Accessibility Review Report – DA

Project Title: **Mona Vale Golf Club**
 3 Golf Avenue, Mona Vale

Job Number: **22006**

Report Version: **22006_ADR_DA_v1.2**

Figure 1 – Lower Ground Level

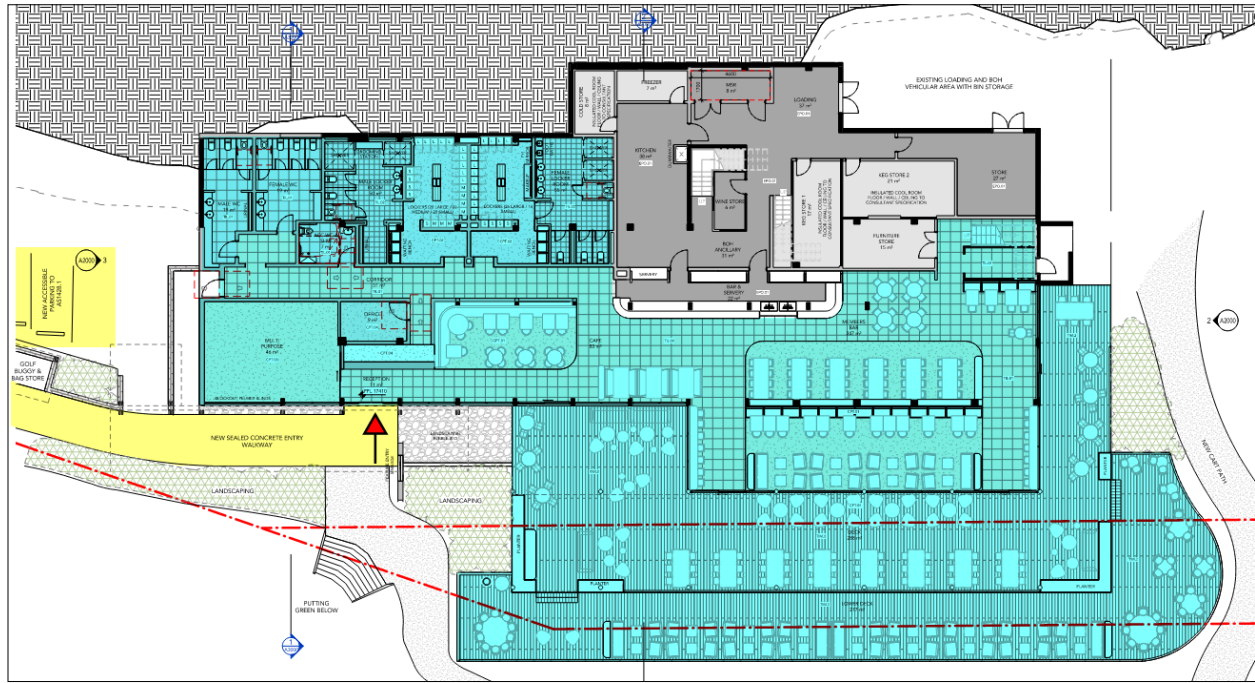
Red arrow highlights Principal Pedestrian Entry

Blue highlights parts of the lower ground floor subject to new works

Yellow highlights external pathways/ parking proposed with new works

Grey/ white identify parts of the building which are existing and not proposed with new works

RE: Ground Level –

Some minor works are proposed on the Ground Floor for fire safety purposes which includes the creating fire isolated shaft around 2x existing stairways, infill of 2x slab penetrations and replacement of doorways leading out to the balcony. If the works on the Ground Floor are deemed as triggering an “affected part” upgrade, which will require the upgrade of the accessible path of travel via the Ground Floor Entry doorways to the area of new works.
